**MONONGAHELA VALLEY ASSOCIATION OF HEALTH CENTERS, INC.
FAIRMONT, WEST VIRGINIA
MVA CLINIC HRSA H8F GRANT RENOVATIONS**

ADDENDUM #2

July 15, 2022

THRASHER PROJECT #060-10256

1 SECOND FLOOR PLAN
 A0.01 1/8" = 1'-0"

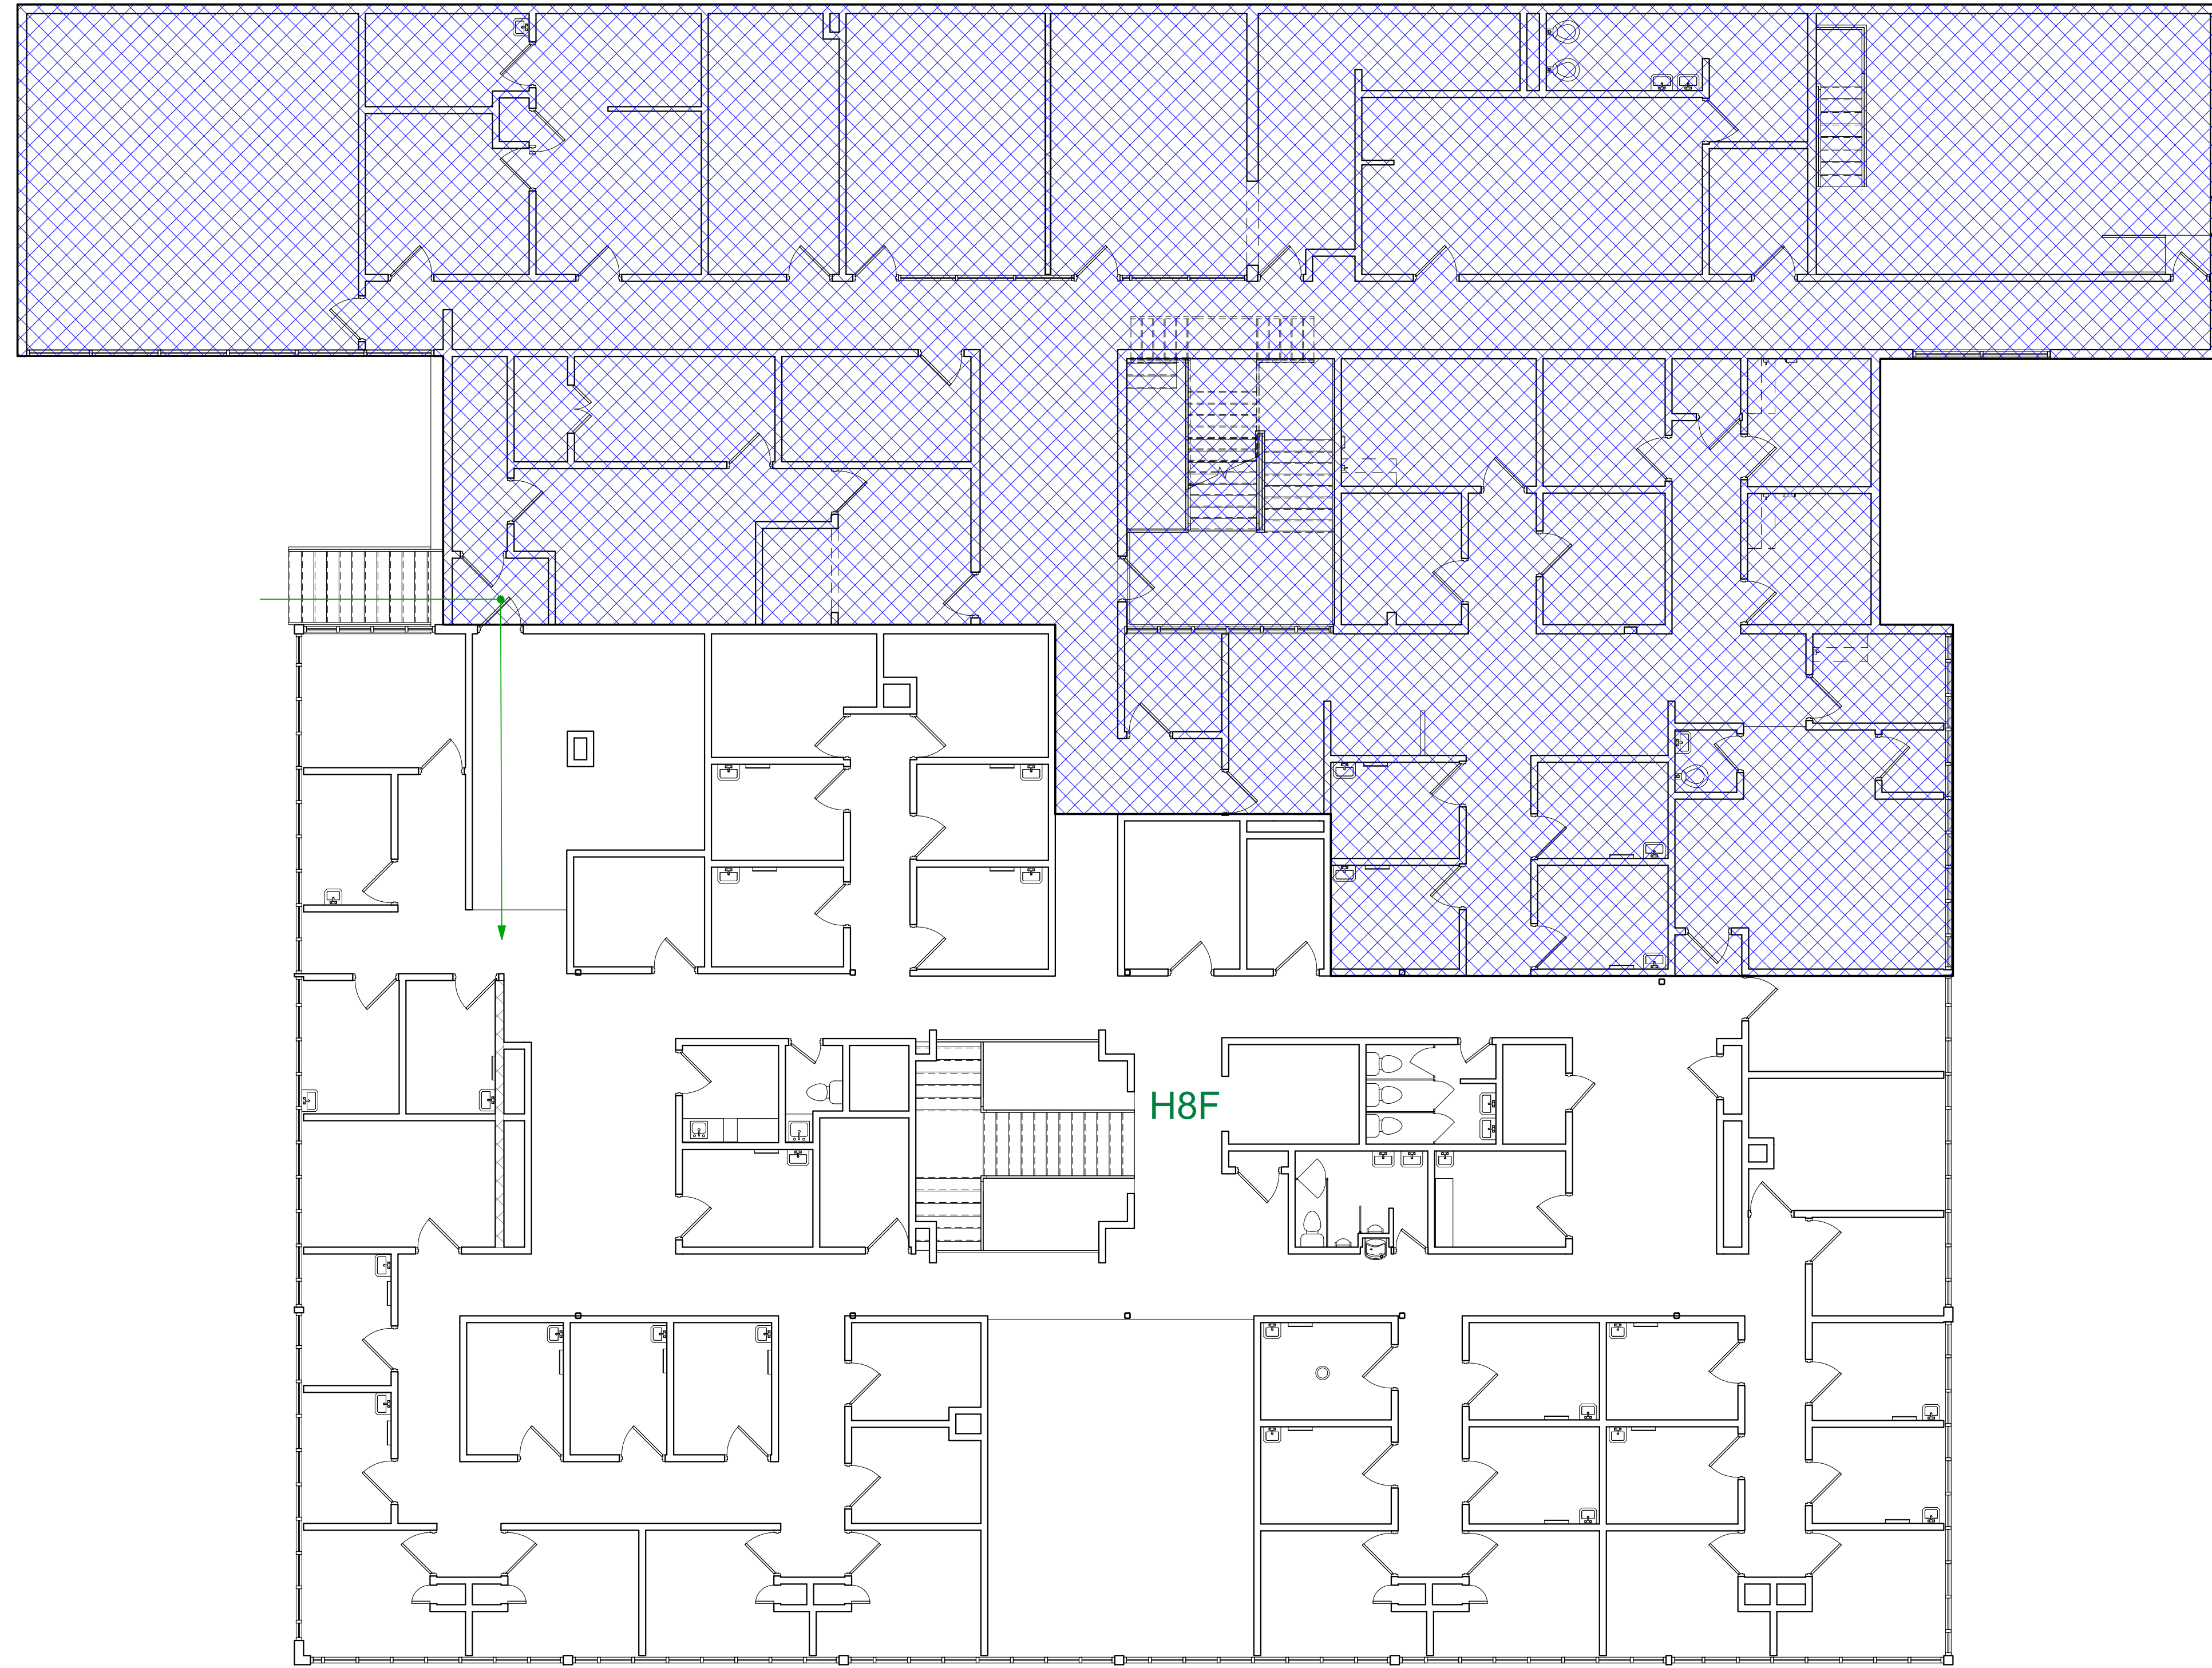
Question 2. Is it possible to get the existing building overall floor plans so we can figure how to access the areas of work for demolition and construction?

Answer 2. Yes, these overall plans are attached to this addendum.
